APPROVAL of a request from KN Butler, LLC (owner) represented by Liz Newell and John Kragie to amend the Butler Mansion PUD Conceptual Plan for property located at 2633 Fleur Drive to allow construction of a building addition and off-street parking to the existing mansion used for commercial offices, subject to the following conditions: (ZON2006-00029)

Request from KN Butler, LLC (owner) represented by Liz Newell and John Kragie to amend the Butler Mansion PUD Conceptual Plan for property						File # ZON2006-00029				
Description of Action	3 Fleur Drive. Amend the Butler Mansion PUD Conceptual Plan for subject property to allow construction of a building addition and off-street parking to the existing mansion used for commercial offices									
2020 Commun Character Plan		Low-Density Residential and Commercial: Pedestrian-Oriented Commercial Corridor								
Horizon 2025 Transportation Plan			No Planned Improvements							
Current Zoning District			PUD Planned Unit Development							
Proposed Zoning District			PUD Planned Unit Development							
Consent Card Responses Inside Area Outside Area			In Favor Not In Favor		Undetermined 0		% Opposition			
Plan and Zonir Commission A	_	A

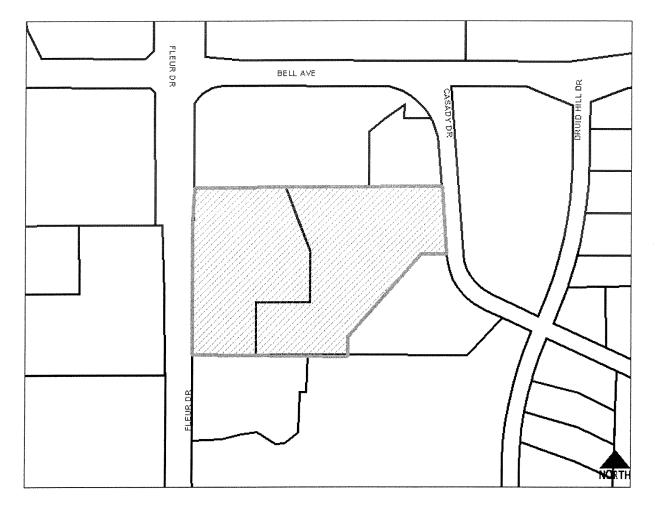
The planting legend on the Concept Plan should be converted to conceptual types of landscaping rather than the specific planting species that is only required for the Development Plan.

7. Additional Information: The submitted PUD Concept Plan is titled "Development Site Plan". This should be revised to state "Butler Mansion PUD Concept Plan". Review and approval of the actual Development Site Plan can only occur upon approval of the amended PUD Concept Plan.

Bruce Heilman: Asked about the parking situation with a 12,000 square foot addition; expressed concern that extension to the southeast could have impact on the adjoining property to the south.

<u>Dr. Donald Jensen</u>, 2872 Druid Hill Drive: Noted one aspect of the premier location of the subject property is the greenspace that surrounds it. Expressed concern for the parking expansion as a result of the green space. Concerned with the parking elevation, the lighting, and the view of downtown;

concerned the parking spaces proposed is 74% greater than what is required by code. Had no concerns with the construction of the building. Questioned whether there was a need for additional parking capacity.

<u>Kent Sovern</u>: Asked about the storm water retention and runoff currently; how the expansion of parking would increase the storm water flow and what remediation was planned.

<u>Kent Sovern</u>: Asked if there would be additional coolers or other external mechanicals that would be part of the project and if there were screening discussions.

<u>Dann Flaherty</u>: Asked if there was a plan to mitigate for the tree that would be taken out.

- 1. Review and approval of the building addition by the City's Landmark Review Board.
- 2. The following modifications are made to the PUD Concept Plan:
 - a) Conversion of the landscaping legend to identify plant types rather than species.
 - b) Revise the name of the document to "Butler Mansion PUD Concept Plan".
 - Provision of landscaping in accordance with the City of Des Moines' Landscape Standards as applicable to the "C-2" District.
- 3. Consideration for permeable paved areas.
- 4. Incorporating additional landscaping.
- 5. Applicant agree to waive any objection to an assessment for sidewalk improvement project at any time in the future requires a project be done through an assessment method.
- 6. Lighting be redirected to not provide any direct lighting onto the adjoining property.
